DEVELOPMENT REVIEW COMMITTEE (DRC) COMMENT REPORT

Project Name: 900 VP, LLC / Residence 900

Case Number: R14035
Request: Site Plan Level III Review / Eleven (11) Multi-Family Units with Yard Modification

Location: 900 NE 4th Street
Zoning: Residential Mid Rise Multifamily / Medium-High Density District (RMM-25)
Land Use: Medium-High Residential

DRAWN	E.F.
CHECKED	G.J.C.
DATE	04/04/2014
SCALE	AS NOTED
JOB. NO.	13-047
SHEET	SP-1

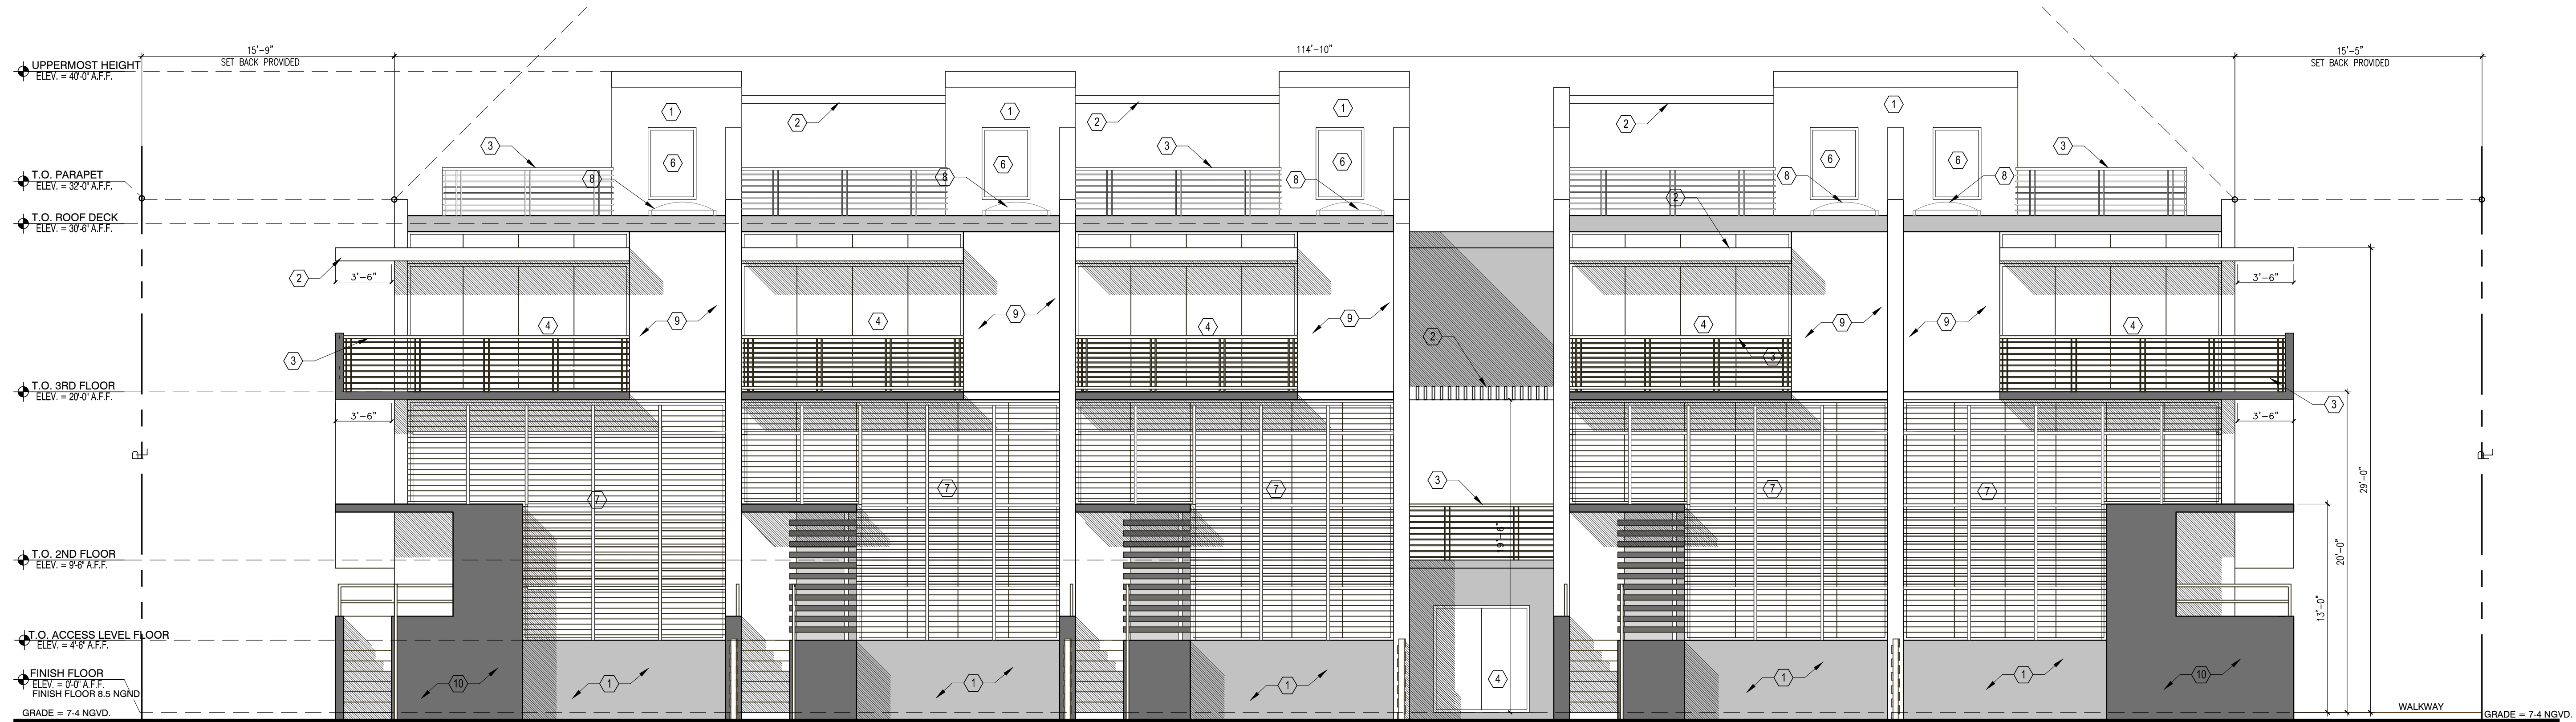
1. Show sight triangle for the intersection of N.E. 9th Avenues and N.E. 4th Street. According to ULDR, the sight triangle is a triangular shaped portion of land established for unobstructed visibility of motorists entering or leaving an intersection in which nothing, whether stationary or moveable (i.e., vehicles, vehicular maneuvering area, signs, landscaping or objects of any kind) is permitted to be located between a height of two and one-half (2½) and eight (8) feet above the adjoining edge of pavement. The sight triangle is measured twenty-five feet (25) from the intersection point of the two intersecting ultimate right-of-way line (property line). In addition, please show the required 15-foot and 10-foot sight triangles for the alley and driveway, respectively, at N.E 9th Avenue.

3. Provide smooth curvilinear transition at the intersection of the sidewalks along N.E. 9th Avenue and N.E. 4th Street.
4. Meet the City's adequacy requirements with respect to services provided to the public (such as fire service, water, sanitary sewer, drainage, transportation, etc.), as per Section 47-25.2 of the City's Land Development Regulations (ULDR). The applicant's engineer shall assess potential demands and impacts on those services and prepare a design for each that utilizes (as is reasonable) any existing water, sewer, drainage, and street infrastructure to adequately serve this project. In the event inadequate infrastructure exists, the engineer must prepare a design that extends/expands to the nearest City system for the purpose of serving this development. The engineer must prepare service demand calculations for water and sewer and obtain a letter of service availability from City's utilities, Alicia Dunne at 954-828-5326 or adunne@fortlauderdale.gov.

8. Discuss the purpose of the two (2) sewer lateral connected to the 10-inch sewer main at N.E. 4 the Street. Are those laterals being disconnected? The site plan shows that all sewer laterals are connected to an existing 10-inch sewer main at N.E. 9th Avenue.

- 12) Discuss placement of the new sidewalk on NE 9th Avenue with engineering representative, as well as the three foot sidewalk proposed along the property line adjacent to the alley as this may create run-off into the alley.

- 17) Provide the following changes on site plan:
 - a. Provide measurement from property line to outer wall of exterior stairwells.
 - b. Indicate all adjacent building footprints, indicating their uses and heights, and dimension approximate setbacks.

- c. Indicate all utilities (both above and below ground) that would affect the proposed planting or landscape plan. Overhead lines (if any) should be placed underground. If the lines cannot be placed underground provide documentation from FP&L indicating such.
